ADDENDUM NO. 1

DATE: 5-28-2024

TO: ALL BIDDERS
FROM: JKF ARCHITECTURE
RE: Lenoir Community College New Aviation Center for Excellence
Project No. 2022-18

To: ALL BIDDERS
From: ATLANTEC ENGINEERS
RE: LENOIR COMMUNITY COLLEGE NEW AVIATION CENTER FOR EXCELLENCE
JKF Project No. 2022-18
Atlantec Project No. 22183

SOUTH ELEVATION (J18)
1/4" = 1'-0"

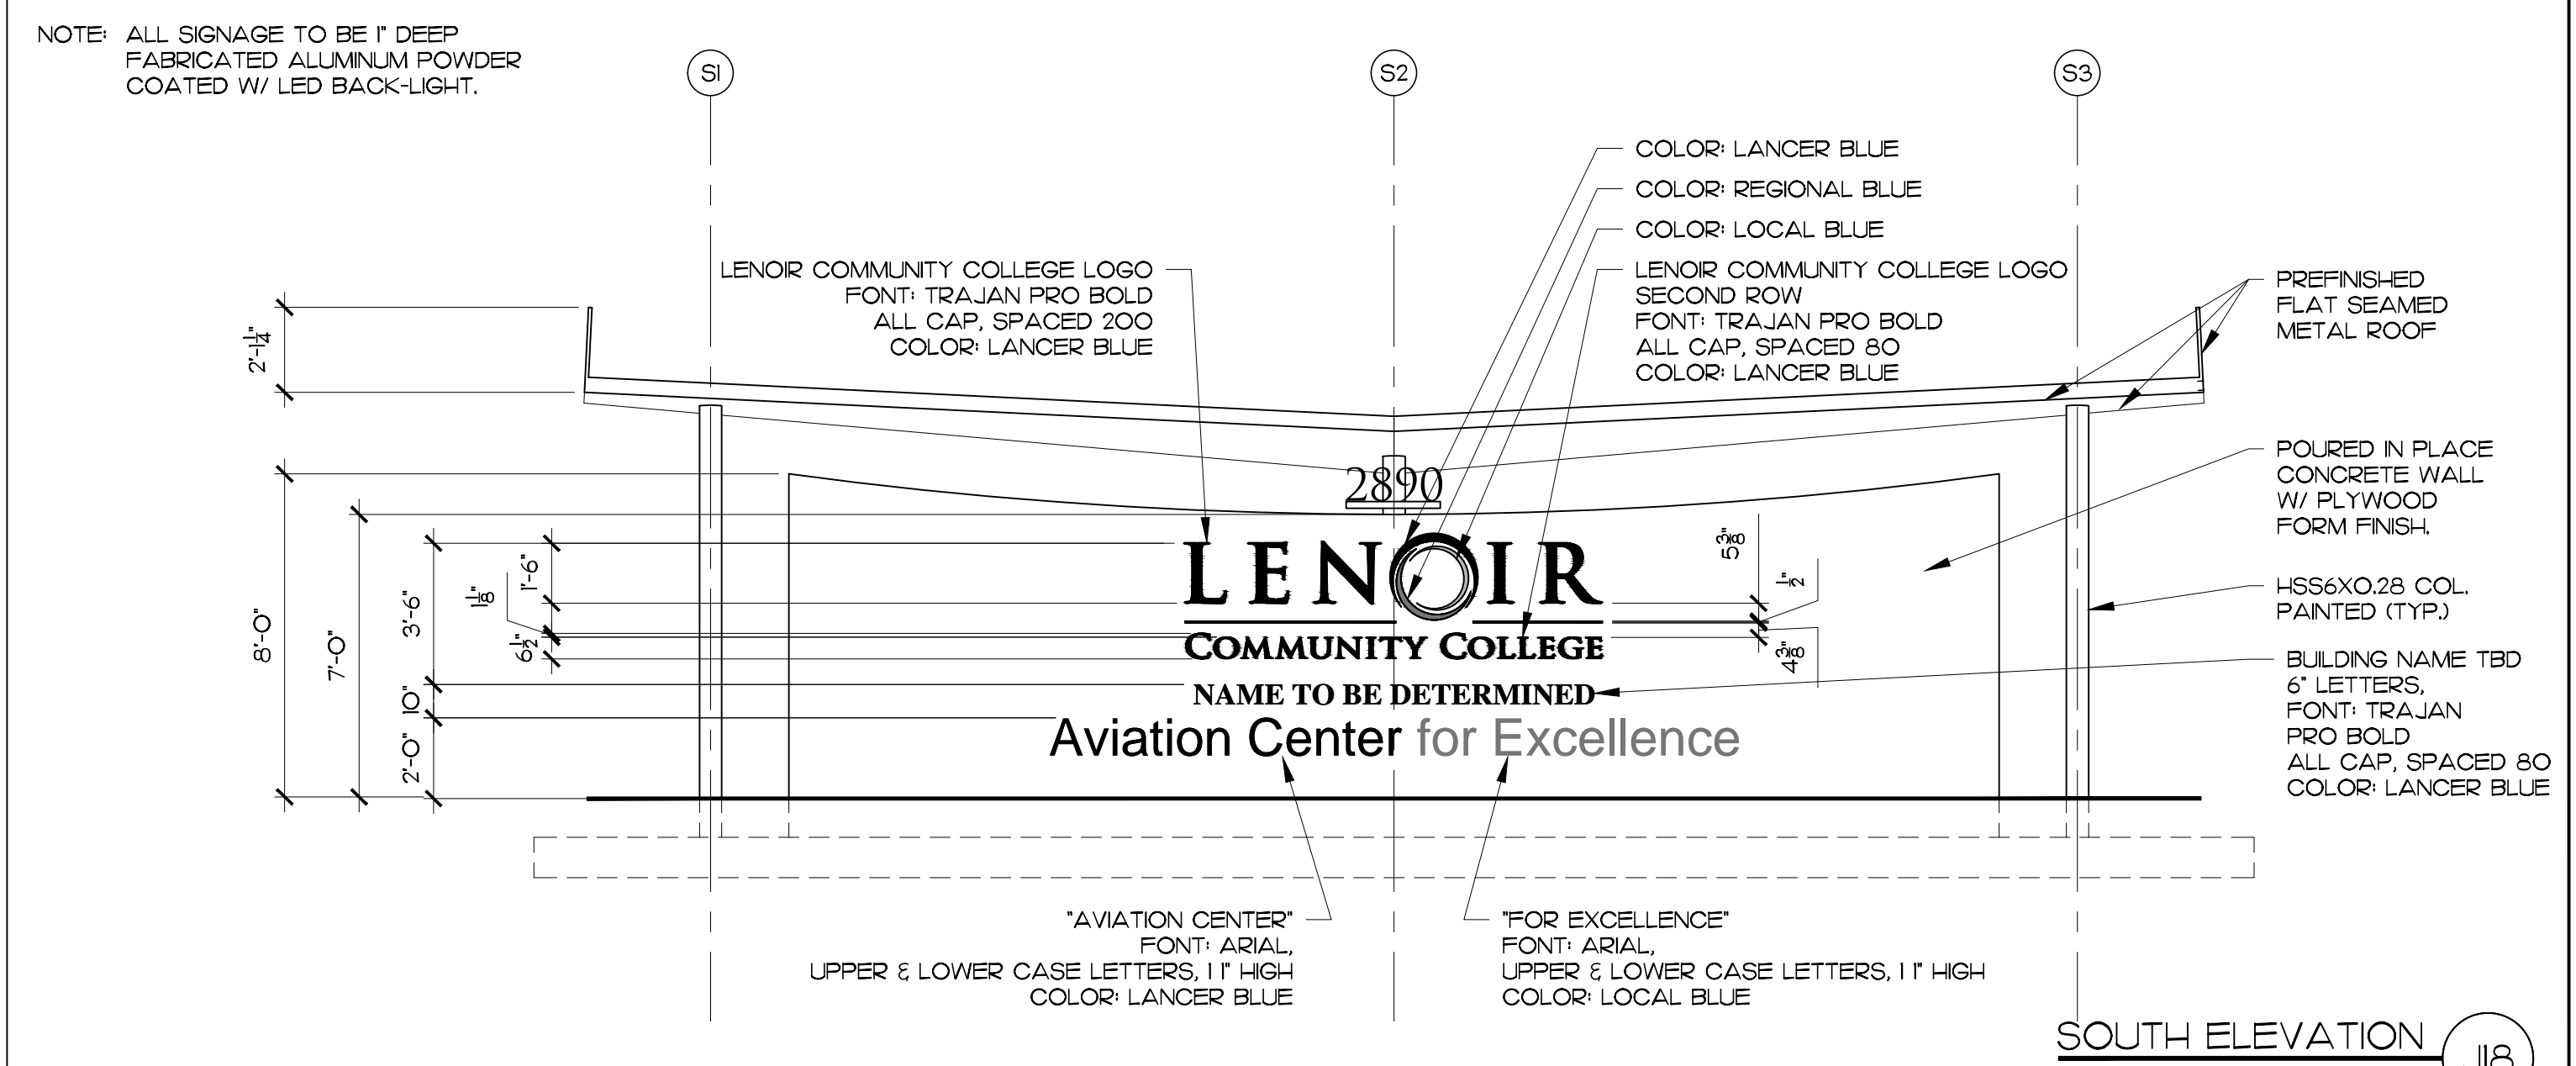
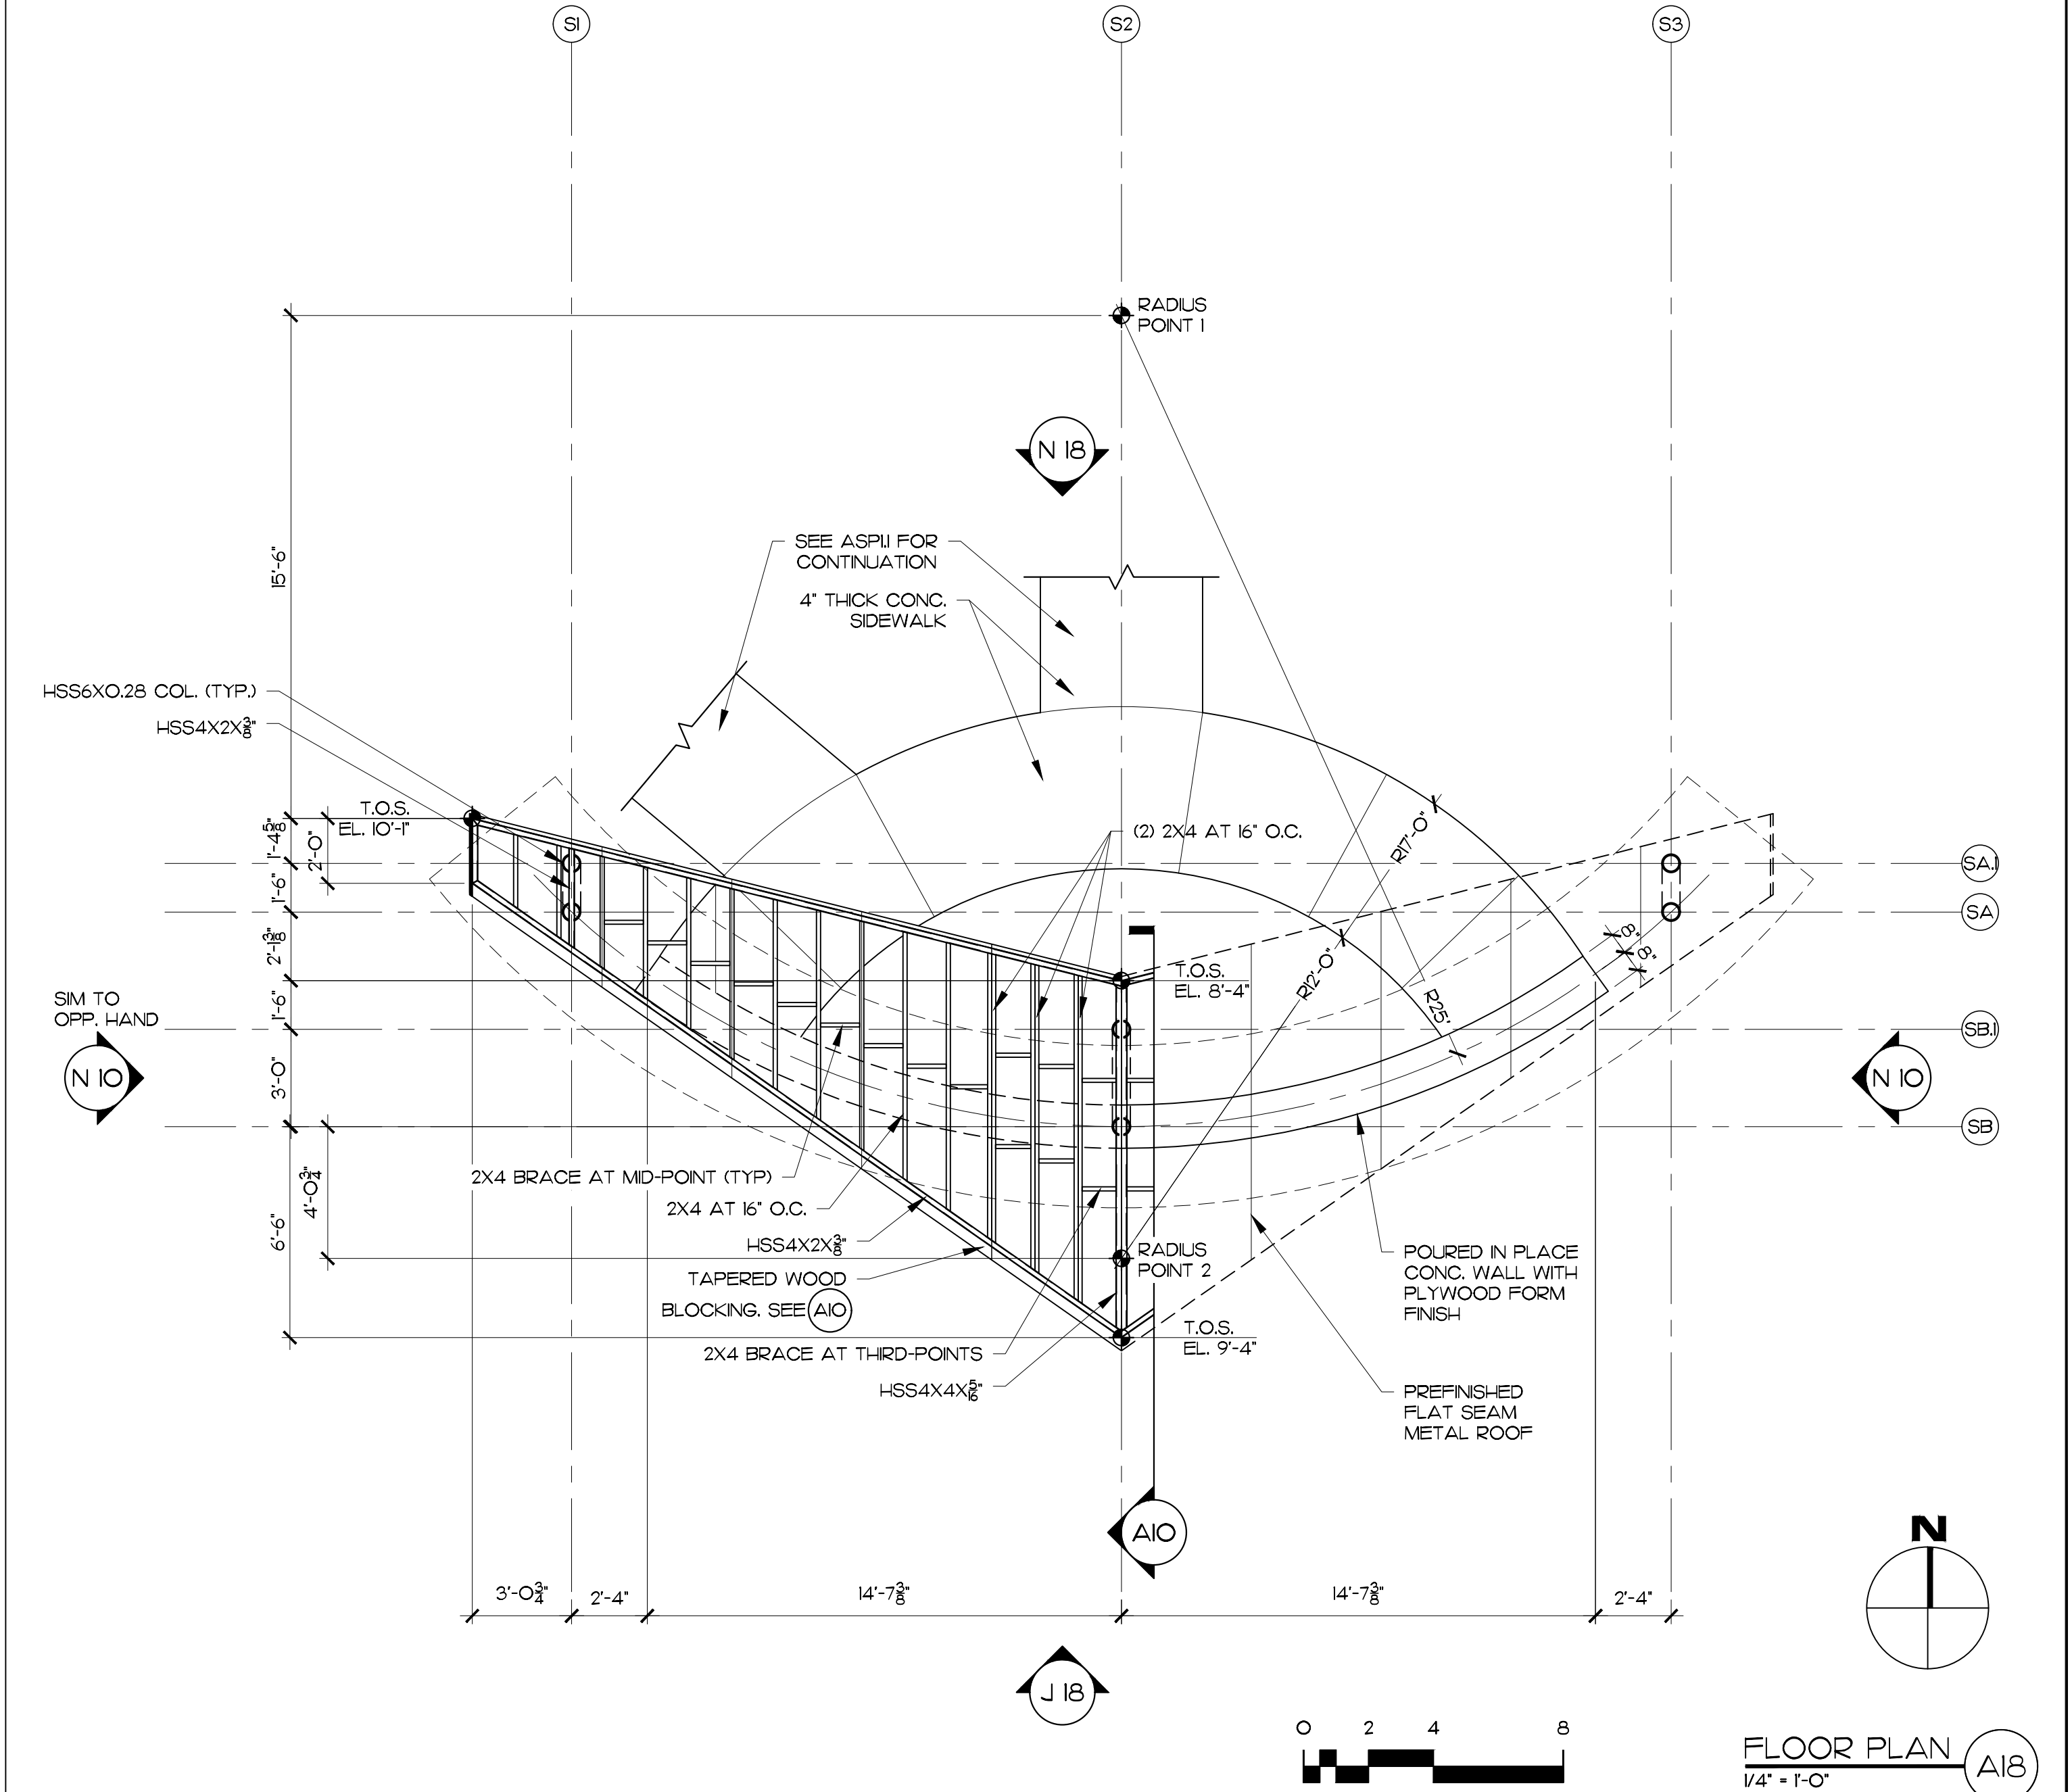
4. Add New Marquee Sign to Drawing ASP1.1, dated 2-28-2024 as follows:

5. Specification Section 101419, dated 2-28-2024; Paragraph 2.2.B is for New Marquee Sign noted on ASP1.1.
 6. Specification Section 101419, dated 2-28-2024; Add Paragraph 2.2.C as follows:
